EN 1996-1-1:2005/AC

Eurocode 6 - Design of masonry structures - Part 1-1: General rules for reinforced and unreinforced masonry structures

Ref. No.: EN 1996-1-1:2005/AC:2009 D/E/F

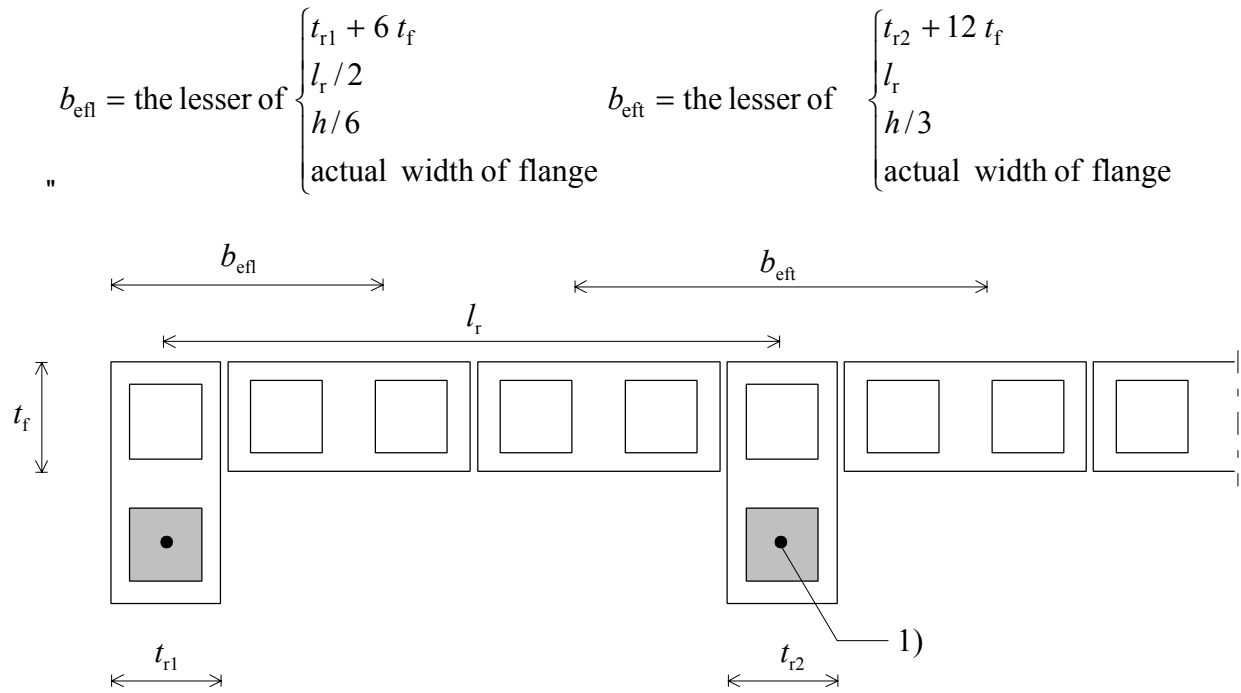
Page 77, paragraph "(5)", equations "(6.24a)" and "(6.24b)", replace "0.4" and "0.3" respectively with "0,4" and "0,3" as follows:

$$M_{Rd} \leq 0,4 f_d b d^2 \quad \text{for Group 1 units other than lightweight aggregate units} \quad (6.24a)$$

$$M_{Rd} \leq 0,3 f_d b d^2 \quad \text{for Group 2, 3 and 4 and Group 1 lightweight aggregate units.} \quad (6.24b)$$

Figure 6.6 — Effective width of flanges

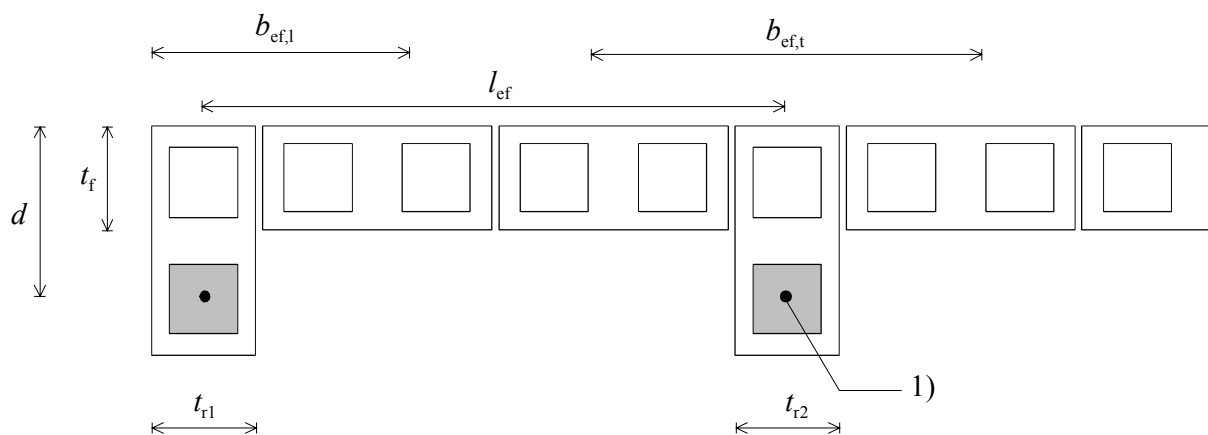
29) Modification to 6.6.3

Page 79, paragraph "(1)", replace:

$$b_{ef,l} = \text{the lesser of } \begin{cases} t_{r1} + 6 t_f \\ l_{ef} / 2 \\ h / 6 \\ \text{actual width of flange} \end{cases} \quad b_{ef,t} = \text{the lesser of } \begin{cases} t_{r2} + 12 t_f \\ l_{ef} \\ h / 3 \\ \text{actual width of flange} \end{cases}$$

- $b_{ef,l}$ effective width of a L-shaped flanged member;
- $b_{ef,t}$ effective width of a T-shaped flanged member;
- d effective depth of the member;
- h clear height of a masonry wall;
- l_{ef} effective distance between lateral restraints;
- t_f thickness of a flange;
- t_{ri} thickness of a rib, i .

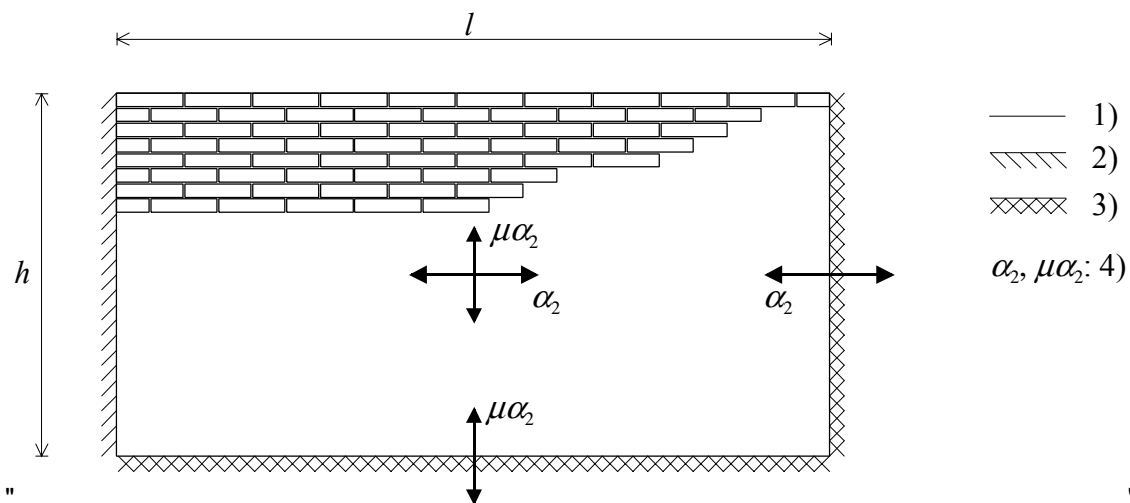
Pages 108 and 109, paragraph "(3)", replace " k_m " with " k_m " in the description of " η " and in equation "(C.2)" as follows:

" η may be obtained experimentally, or it may be taken as $(1 - k_m/4)$,

$$k_m = \frac{n_3 \frac{E_3 I_3}{l_3} + n_4 \frac{E_4 I_4}{l_4}}{n_1 \frac{E_1 I_1}{h_1} + n_2 \frac{E_2 I_2}{h_2}} \leq 2 \quad \text{(C.2)}$$

Page 112, "Figure E.1", replace the figure with the following one:

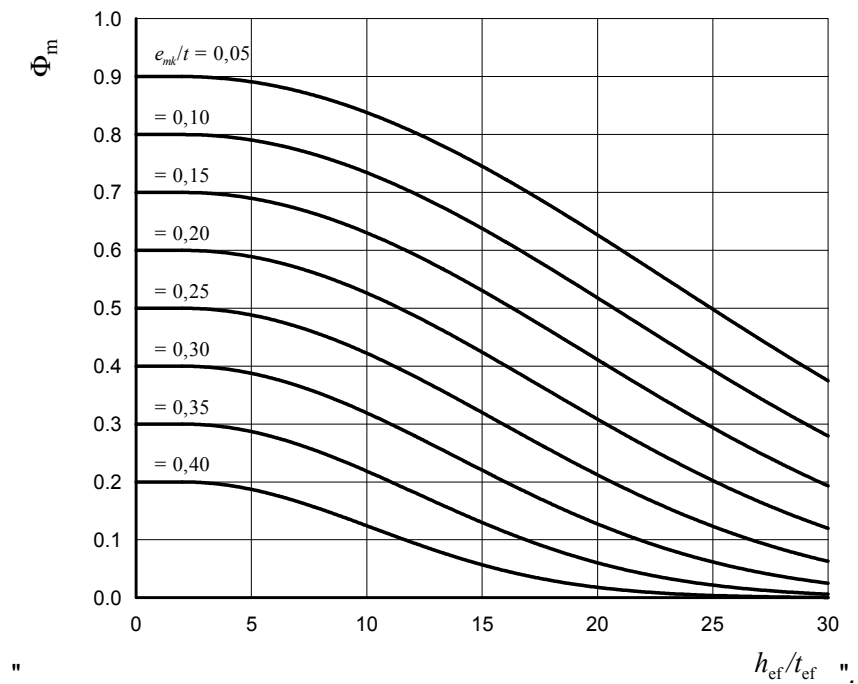
Page 112, "Figure E.1", key "4)", delete " $\alpha_2, \mu\alpha_2$:" as follows:

"4) moment coefficients in the indicated directions".
